ADDENDUM #1

February 14, 2024
KCI No. E0670600

PROJECT: Paving Upgrades at Clarence Galm ES

1 **HMAC PAVEMENT SECTION**
NTS

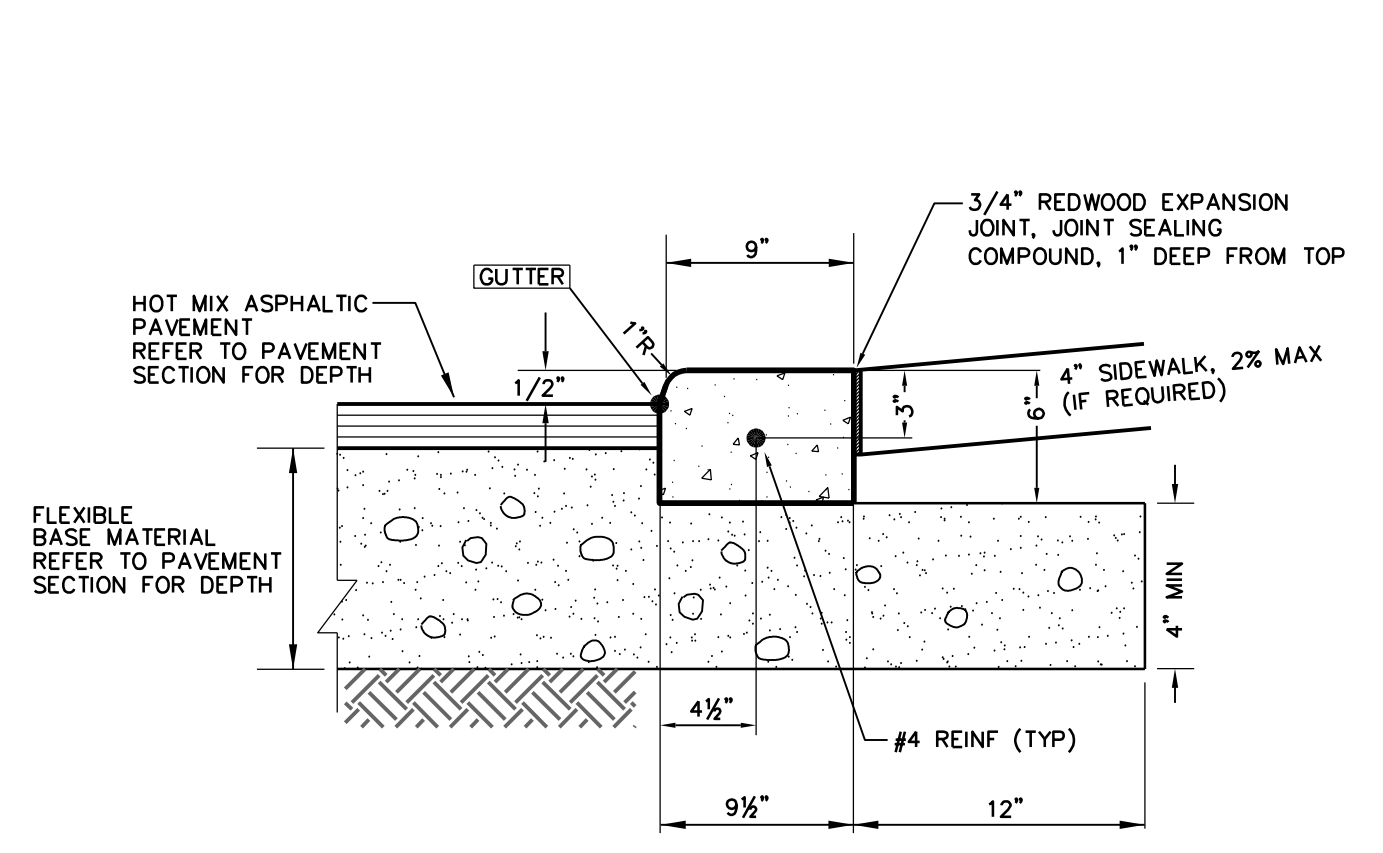
- Item No.1 – Change in sheet C3.5, detail #1 HMAC Pavement Section:
 - HMAC, Flex Base, and Subgrade thickness for parking area, Access Drive, and truck lane have been revised to match the provided Geotechnical Engineering Study Job No. 2024-06 by Arias.
- Item No.2 – Change in sheet C3.5, detail #2 Concrete Pavement:
 - Concrete thickness for parking area, Access Drive, and truck lane have been revised to match the provided Geotechnical Engineering Study Job No. 2024-06 by Arias.
- Item No.3 – Change in sheet C0.1, geotechnical report information:
 - Paving note 55.1 has been revised to match the provided Geotechnical Engineering Study Job No. 2024-06 dated February 08, 2024, by Arias.

TYPE	PARKING AREA LIGHT DUTY	ACCESS DRIVE, TRUCK LANE MEDIUM DUTY
X	HMAC 2.0"	CLAY 3.0"
Y	FLEXBASE 8.0"	CLAY 12.0"
Z	SUBGRADE 6.0"	CLAY 6.0"

2 **CONCRETE PAVEMENT**
NTS

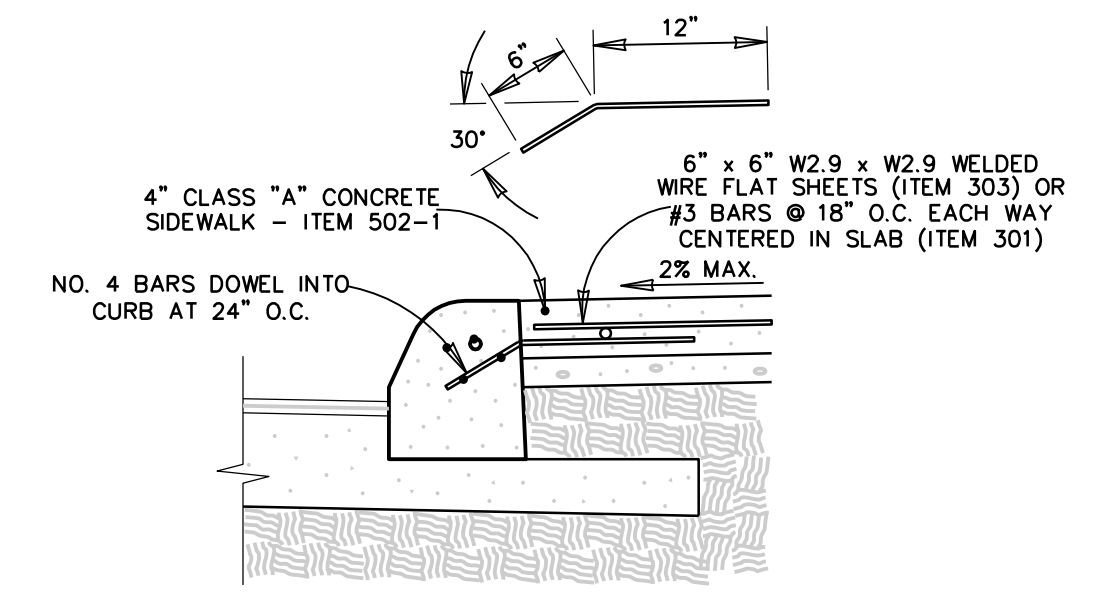
- Item No.3 – Item #12 “Unit cost per square yard (SY) to provide and install 7” concrete pavement per Detail #2, Sheet C3.5” has been revised from “Unit cost per square yard (SY) to provide and install 5” concrete pavement per Detail #2, Sheet C3.4” to the unit price list in accordance with Geotechnical Engineering Study Job No. 2024-06 by Arias.

TYPE	PARKING AREA LIGHT DUTY	ACCESS DRIVE, TRUCK LANE MEDIUM DUTY
W	CONCRETE 6.0"	CLAY 7.0"
X	REINFORCEMENT #4 BARS @ 18" O.C.E.W. 3.0" 1/2"	CLAY 6.0"
Y	CONCRETE 6.0"	CLAY 7.0"
Z	SUBGRADE 6.0"	CLAY 6.0"
